CITY OF FRANKLIN  
PLAN COMMISSION MEETING\*  
FRANKLIN CITY HALL COUNCIL CHAMBERS  
9229 W. LOOMIS ROAD, FRANKLIN, WISCONSIN  
AGENDA  
THURSDAY, AUGUST 5, 2021, 7:00 P.M.

## REPORT TO THE PLAN COMMISSION

<b>Project Name:</b>	Pleasant View Reserve NRSE and Final Plat
<b>Project Location:</b>	Approximately S. 49 <sup>th</sup> Street and Marquette Avenue (Tax Key No: 788-9981-003 and 759 9981 010)
<b>Property Owner:</b>	Creative Homes Inc. (788-9981-003) and Franklin 49 <sup>th</sup> St. LLC (759 9981 010)
<b>Applicant:</b>	Matt Cudney, Veridian Homes
<b>Agent:</b>	Grant Duchac, Excel Engineering Inc.
<b>Current Zoning:</b>	R-6 Suburban Single-Family Residence District
<b>2025 Comprehensive Plan:</b>	Residential and Areas of Natural Resource Features
<b>Use of Surrounding Properties:</b>	Single-family residential to the north, a public school and public park to the east, single family residential to the south, and institutional/senior housing, single family residential, and Payne & Dolan quarry to the west.
<b>Applicant's Action Requested:</b>	Recommendation to the Common Council for approval of the Natural Resource Special Exception Application, and the Final Plat.

**FIGURE 1**  
**NATURAL RESOURCE PROTECTION PLAN**

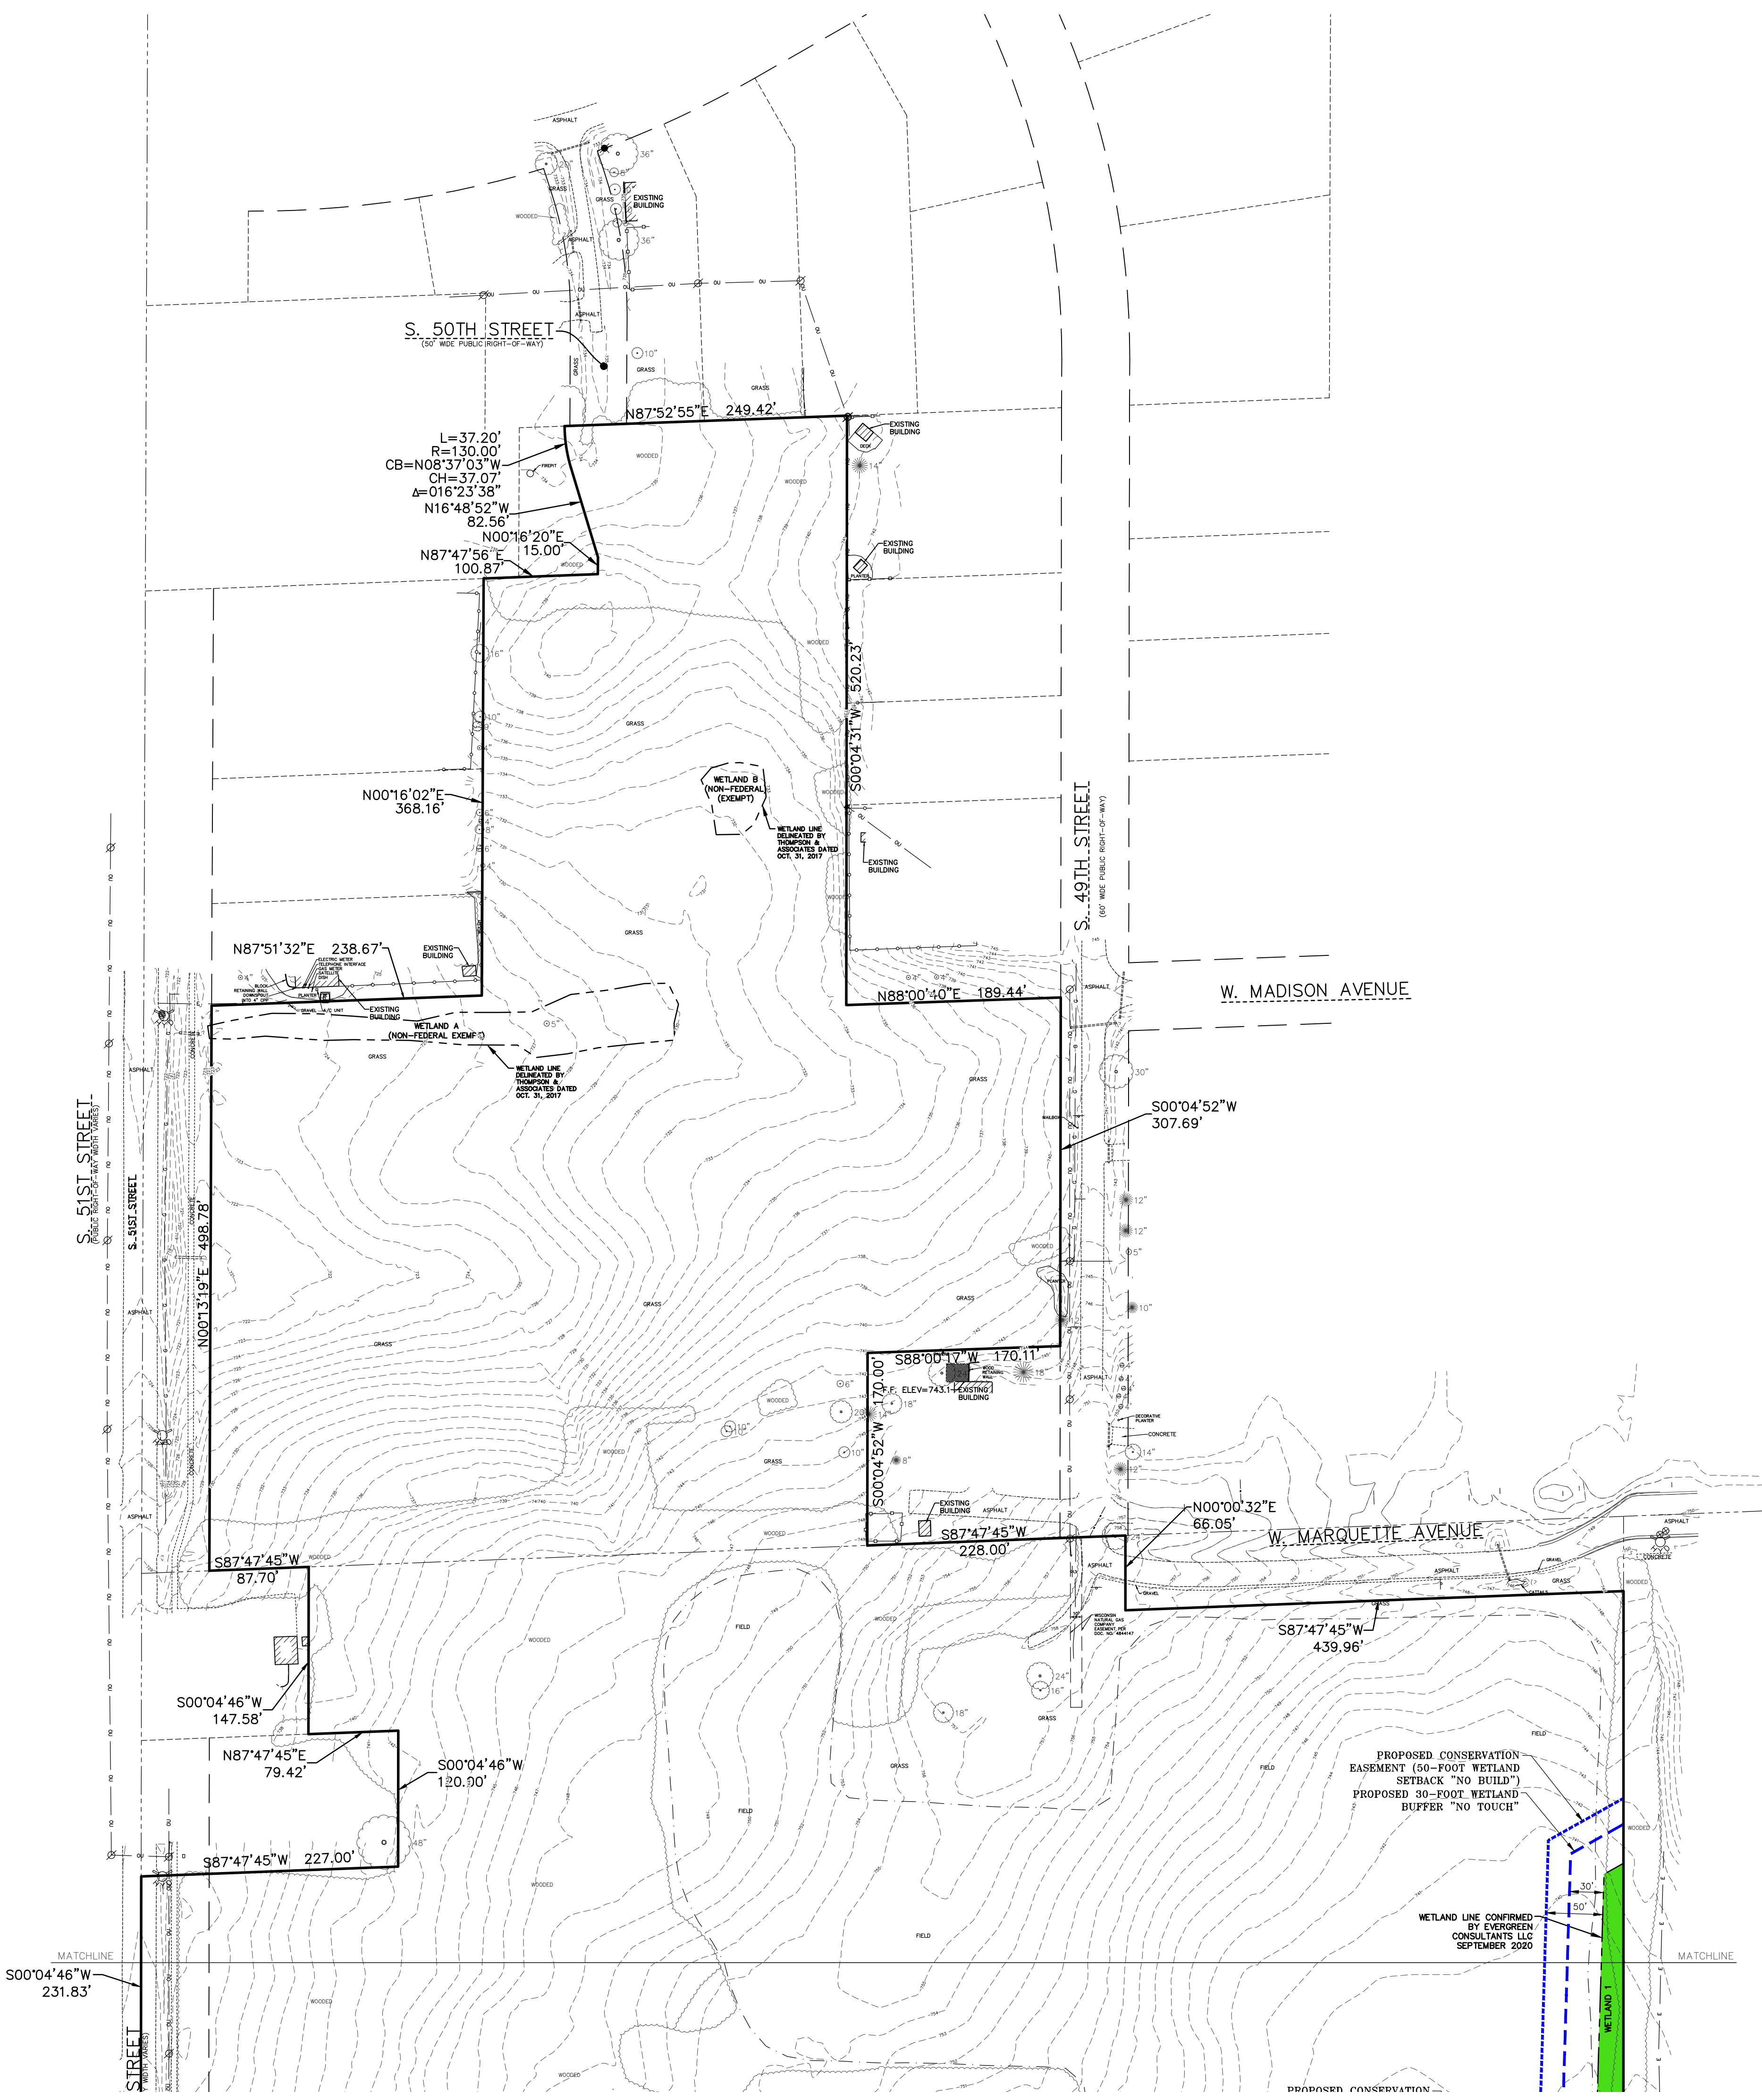
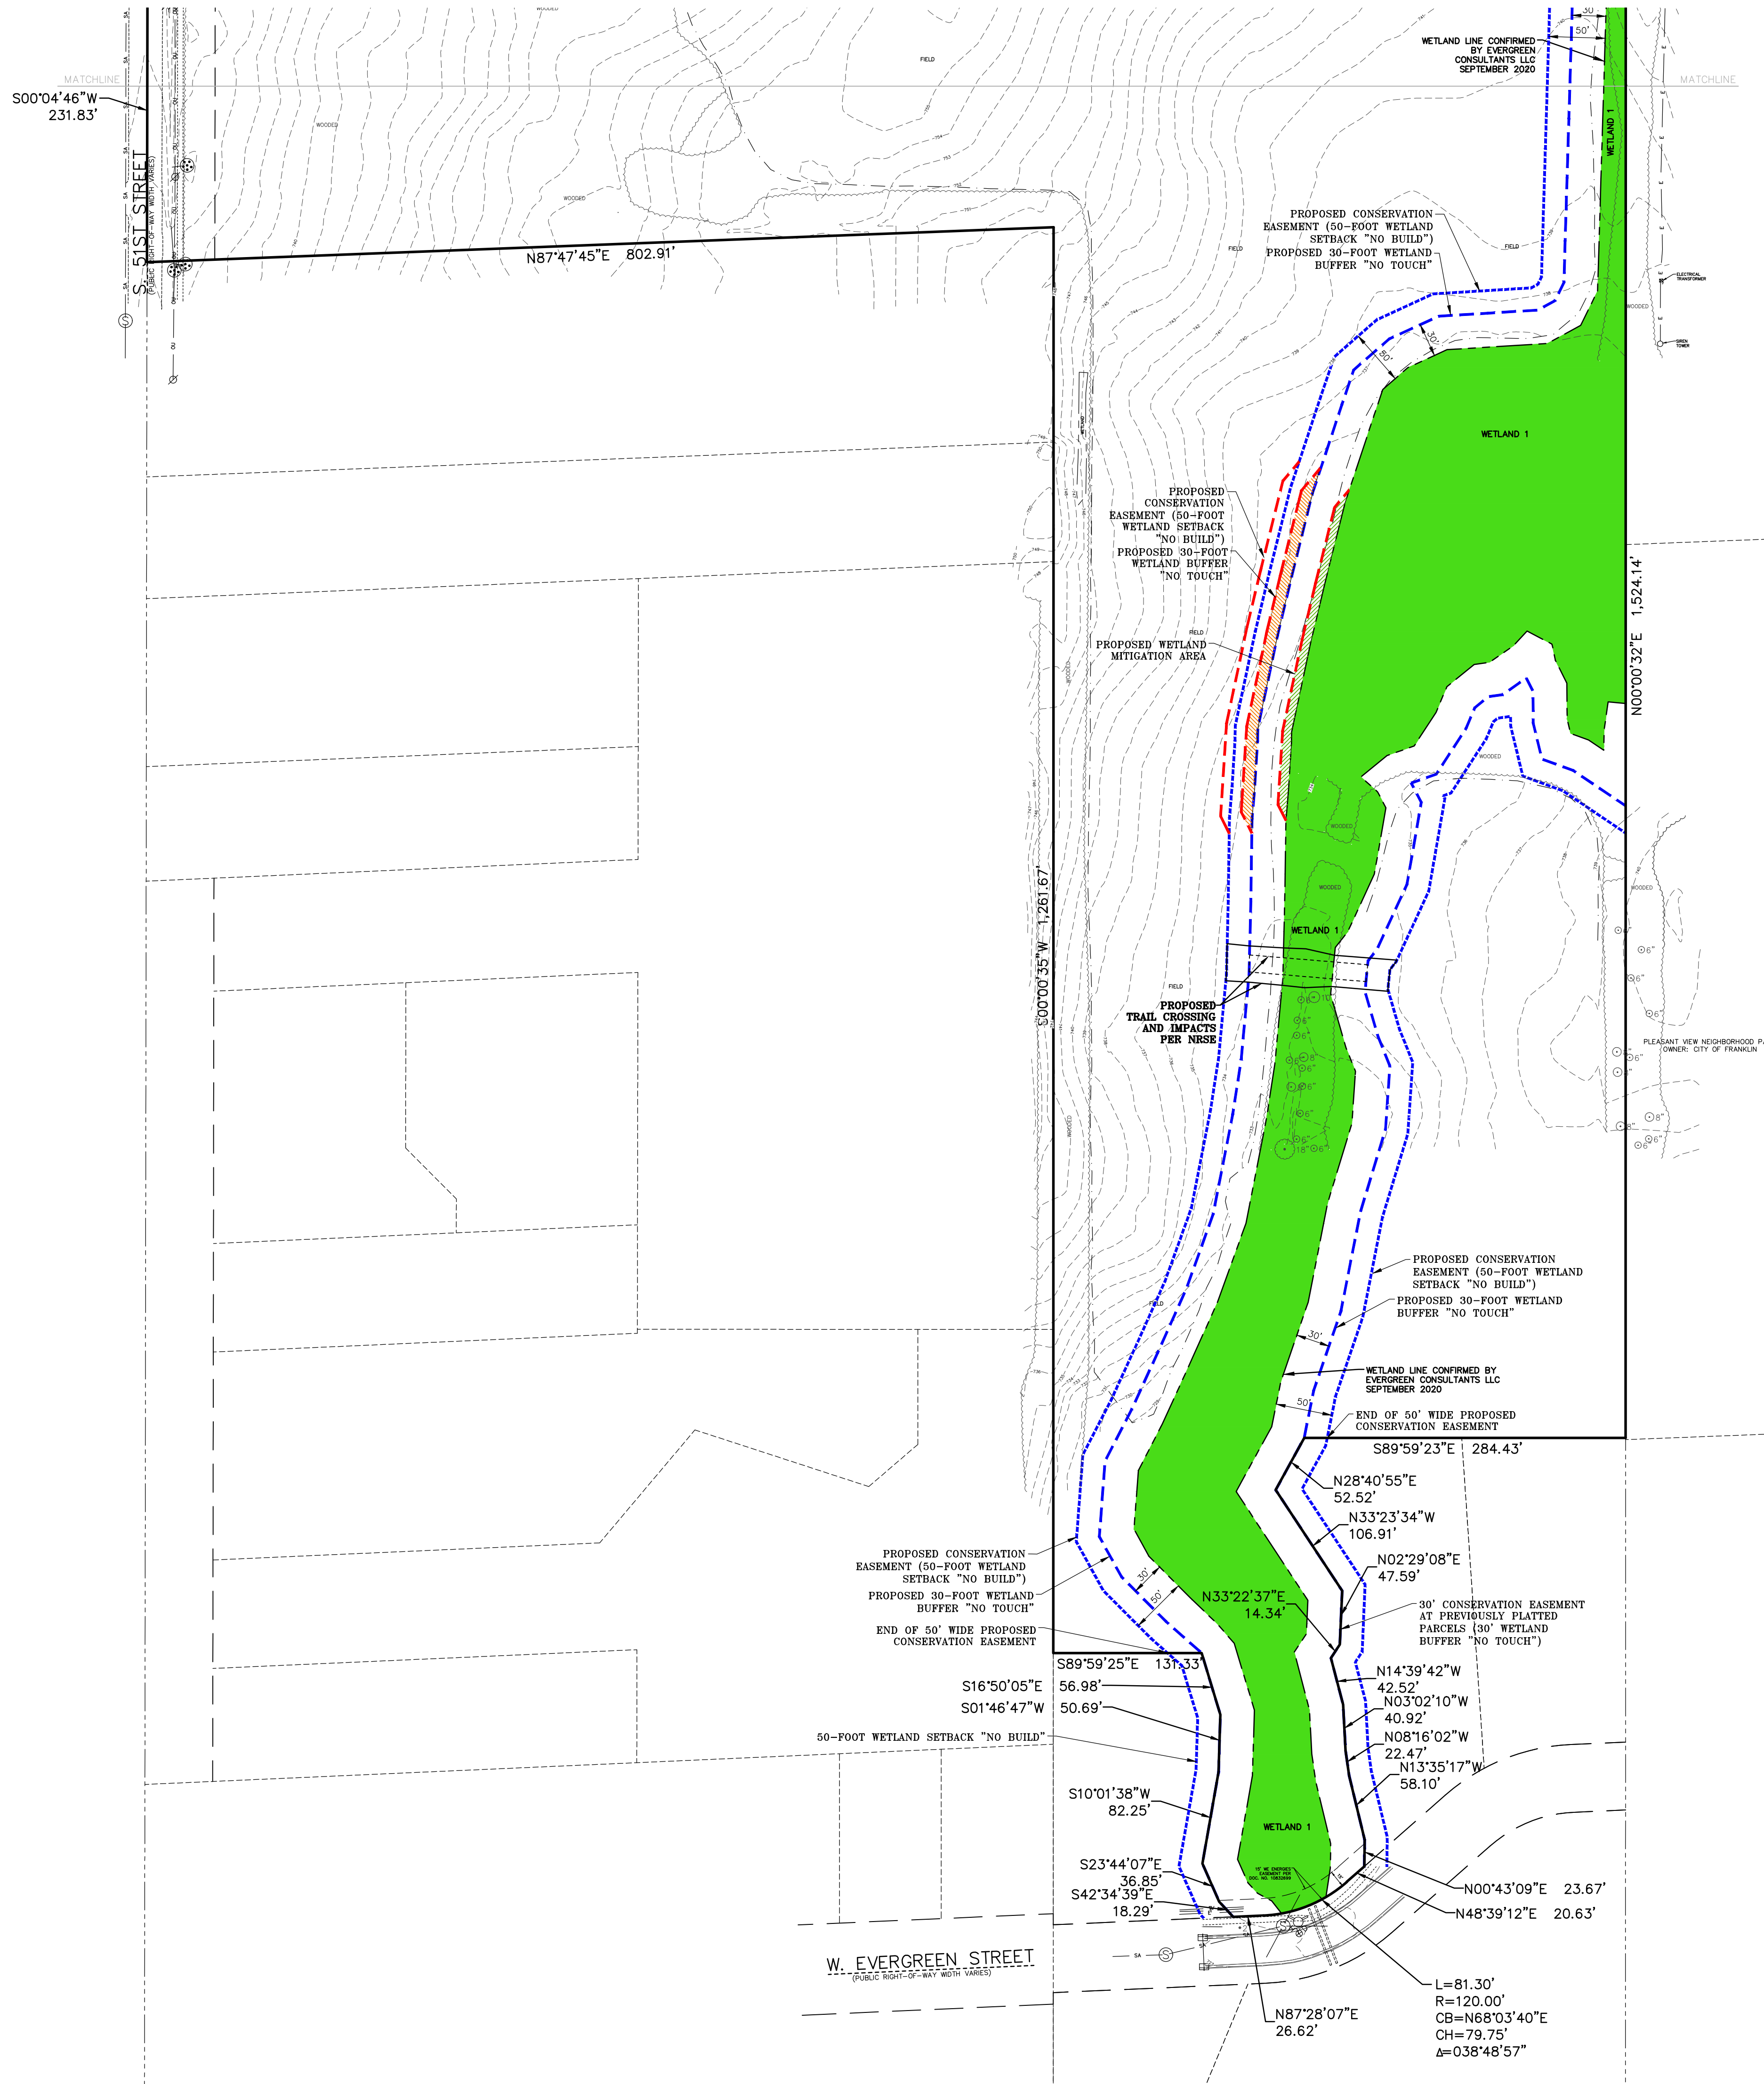
A number of technical corrections to the Natural Resource Protection Plan must be made, including addition of a table with consolidated information about all natural resources and degree of impact, and corrections to site intensity calculations, as required by §15-7.0201 §15-4.0102, and §15-7.0201.I, etc.

18. The applicant shall revise site intensity calculations to reflect the total wetland area of Wetland 1, or provide documentation of the amount listed in site intensity calculations, for Department of City Development review and approval prior to recording of the Final Plat.

- 7) The applicant shall make all necessary technical corrections to the Natural Resource Protection Plan, subject to the approval of the Department of City Development.*
